UNITED STATES PATENT AND TRADEMARK OFFICE

| APPLICATION NO. | FILING DATE | FIRST NAMED INVENTOR | ATTORNEY DOCKET NO. | CONFIRMATION NO. |
|-----------------|-------------|----------------------|---------------------|------------------|
| 10/709,480 | 05/08/2004 | Timothy Kingston | 07589.0164.PCUS00 | 1683 |

Office Action Summary

DETAILED ACTION

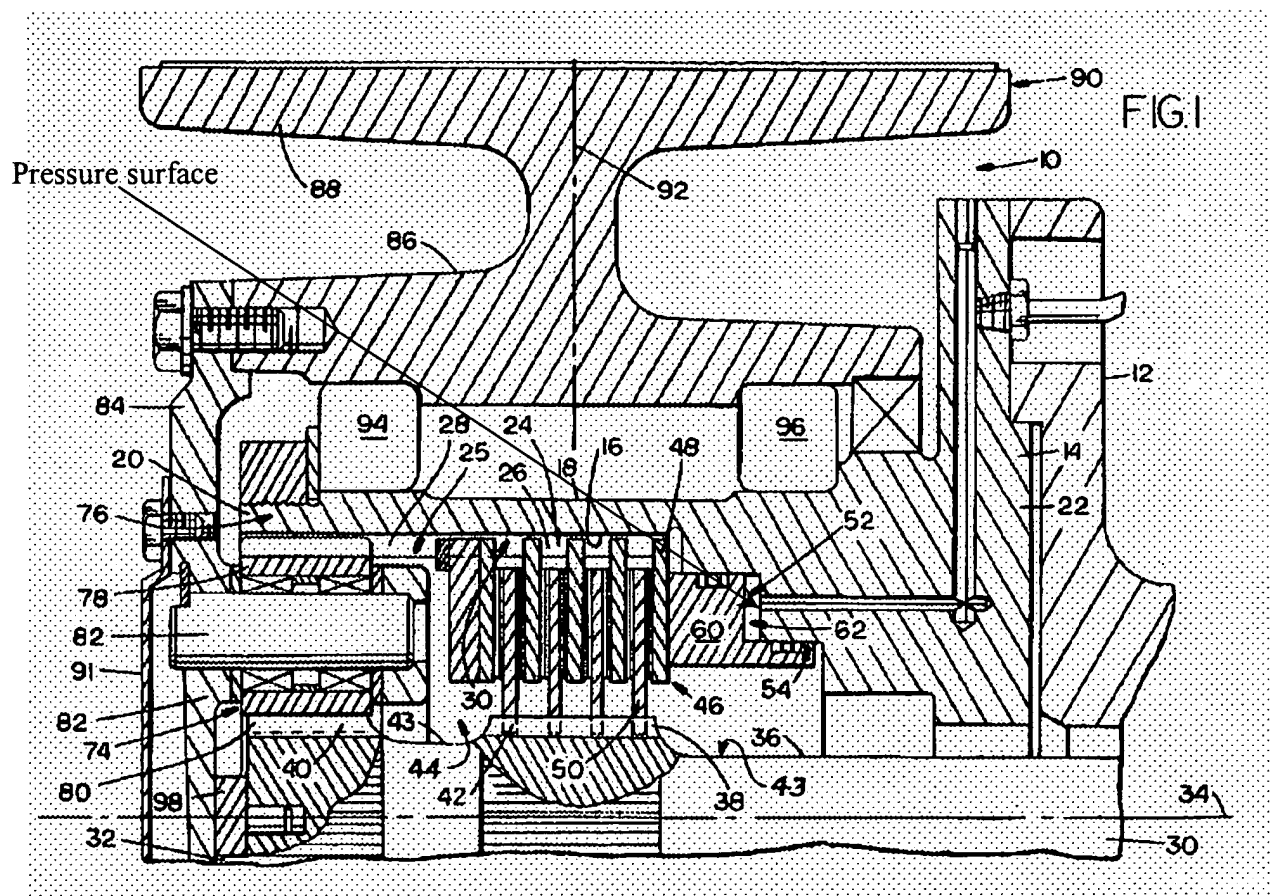
Regarding claim 3, wherein the hub 86 is mounted against the annular member outside in the radial direction of that portion of the annular member which forms the ring gear 76, and also against said portion.

Regarding claim 5, wherein the annular member forms a pressure surface (see the Fig. below) for said braking device.

Regarding claim 6, wherein the outer, static part (16, 18) forms a portion of a brake housing for the braking device.
